CR11
Rearrangement of
Undulator Positron Source

Wei Gai (ANL)
Masao Kuriki (Hiroshima)
Toshiyuki Okugi (KEK)

8-Dec-2015
CMB Meeting

The Points

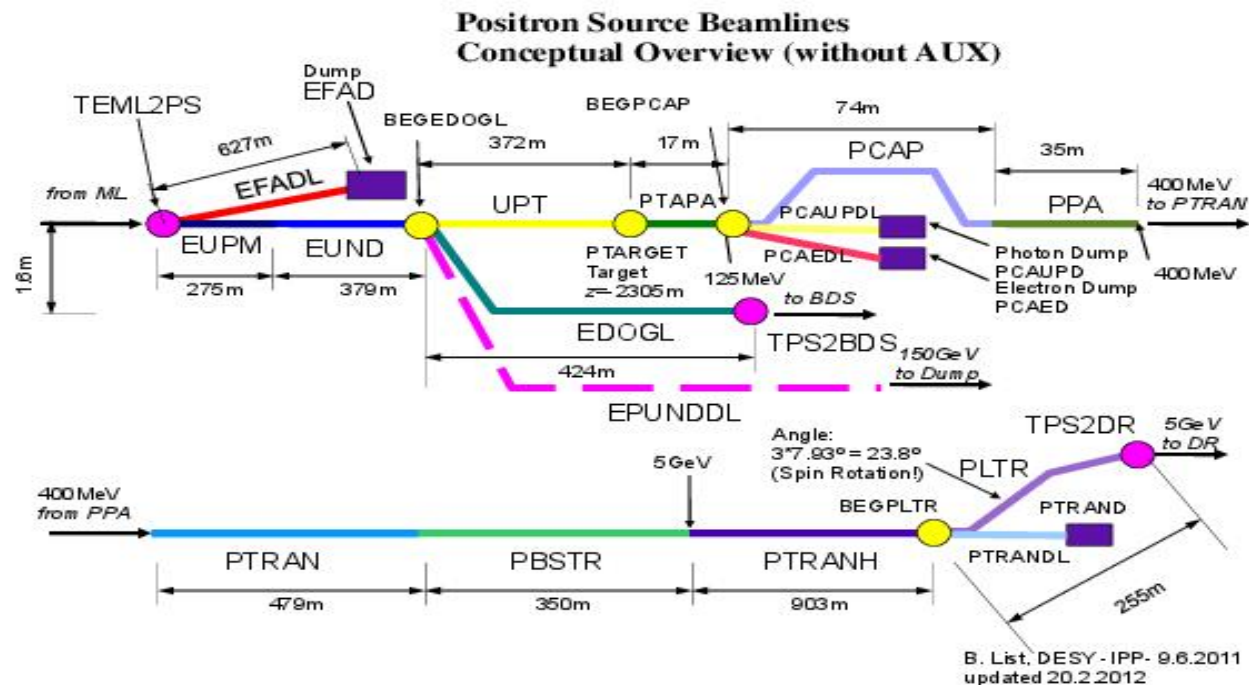
- Rearrange Undulator Positron Source for
 - Higher flexibility
 - Better performance
- Relocate PBSTR to upstream to shorten PTRAN.
- Relocate ECS (Energy Compressor Section) to upstream.
- Relocate Path Length Adjuster to downstream of ECS.

Relocation of PBSTR

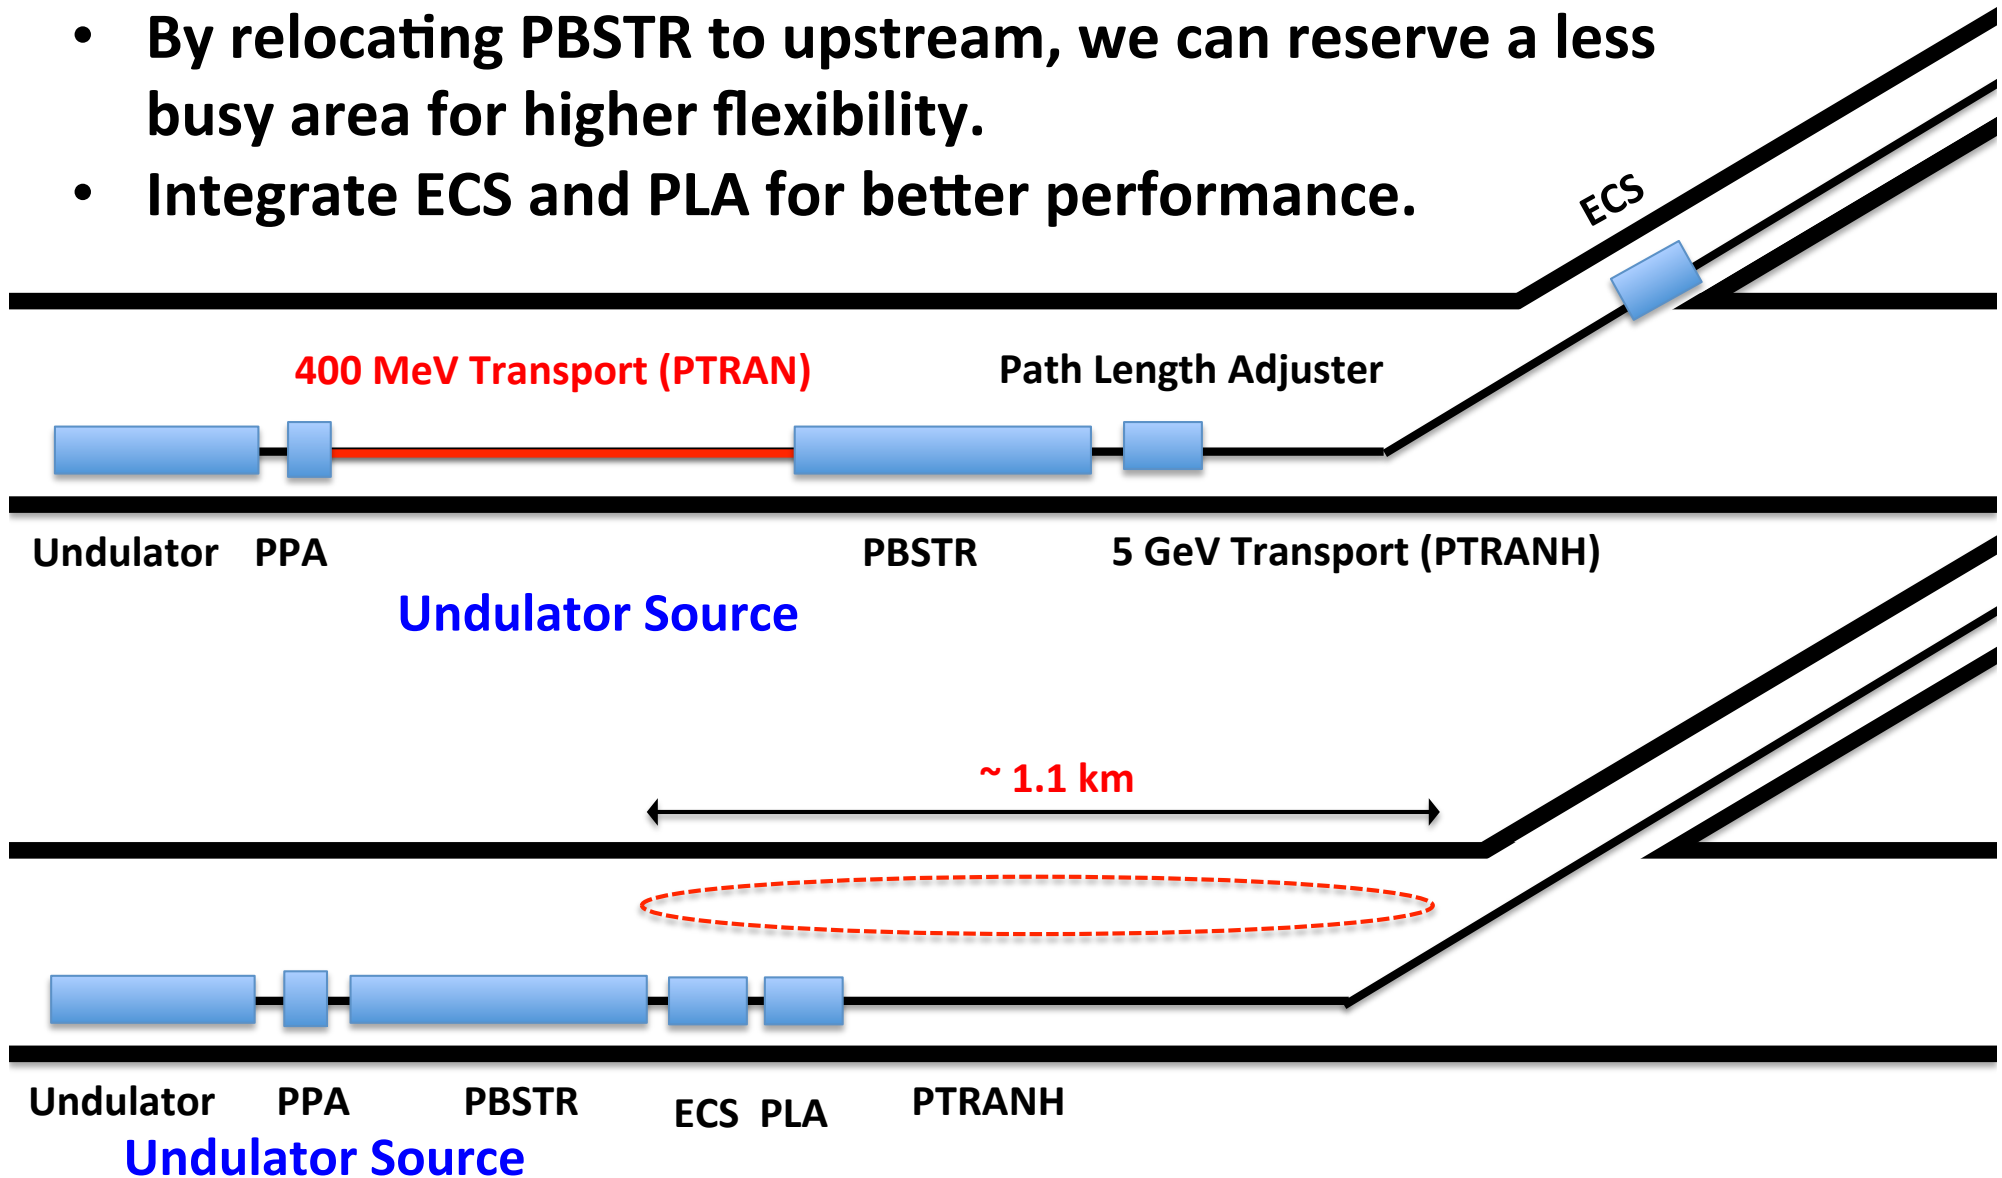
- By relocating PBSTR to upstream, we can reserve a less busy area for higher flexibility.
- Integrate ECS and PLA for better performance.

R_{56} of ECS

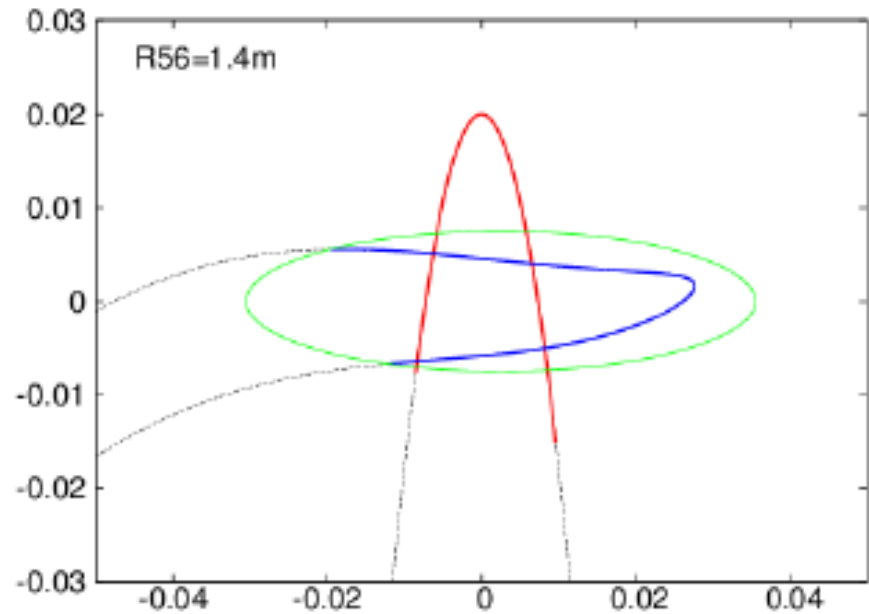
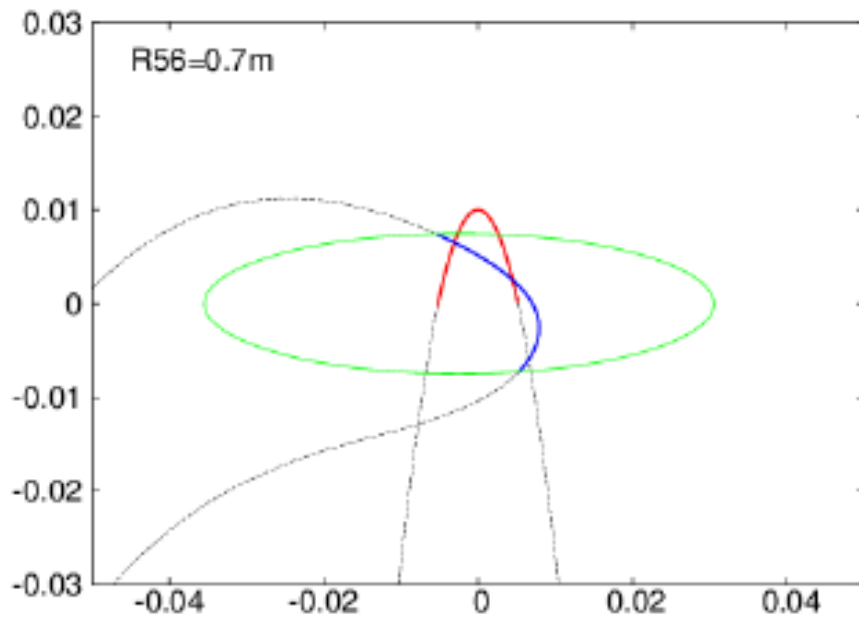
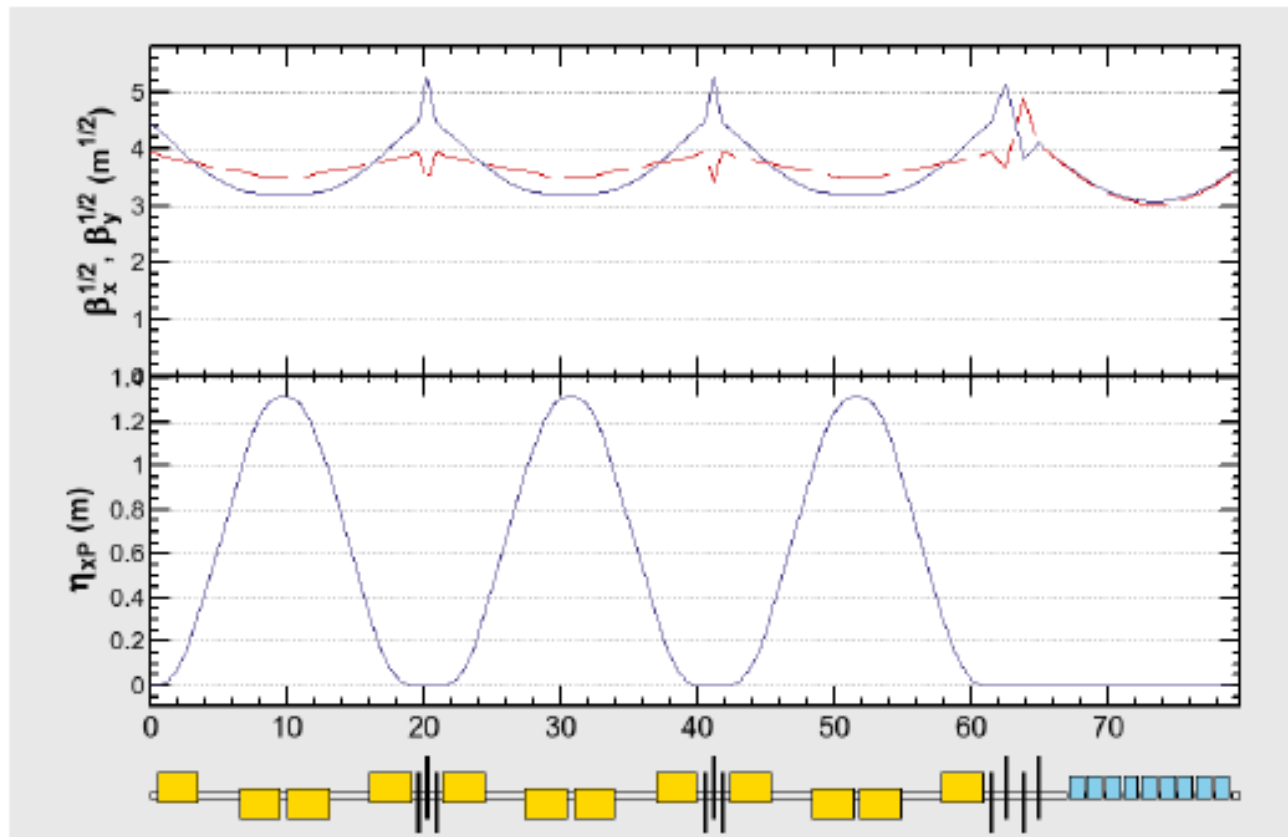
- 1.4 m R_{56} of ECS gives a better phase space matching to DR acceptance comparing to 0.7 m (TDR).

Beam Optics for Energy Compressor with $R56=1.4\text{m}$

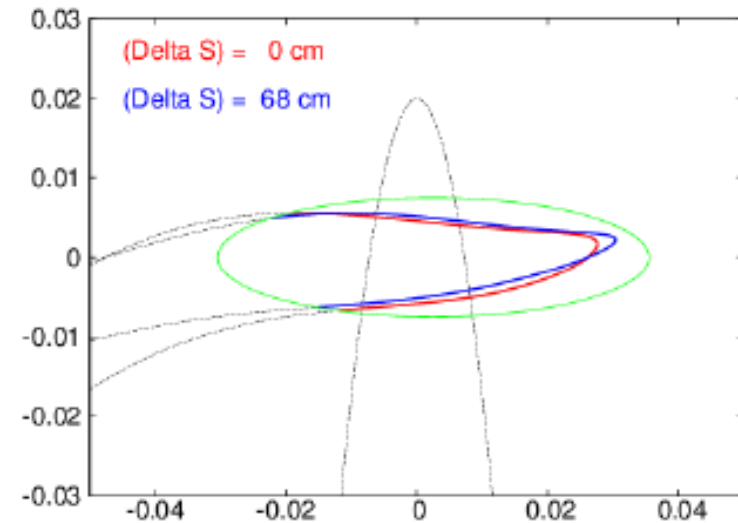
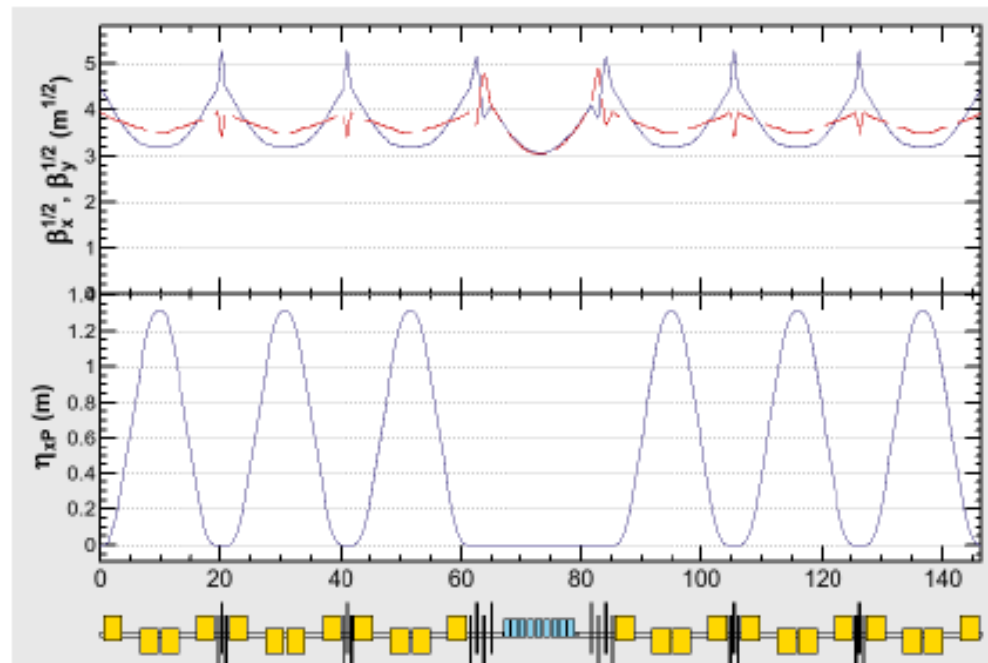
$B = 1.2 \text{ T}$
3 chicanes
 $R56 = 1.4\text{m}$

9 x 9 cell cavity
(Type A module)
 $V = 131 \text{ MV}$
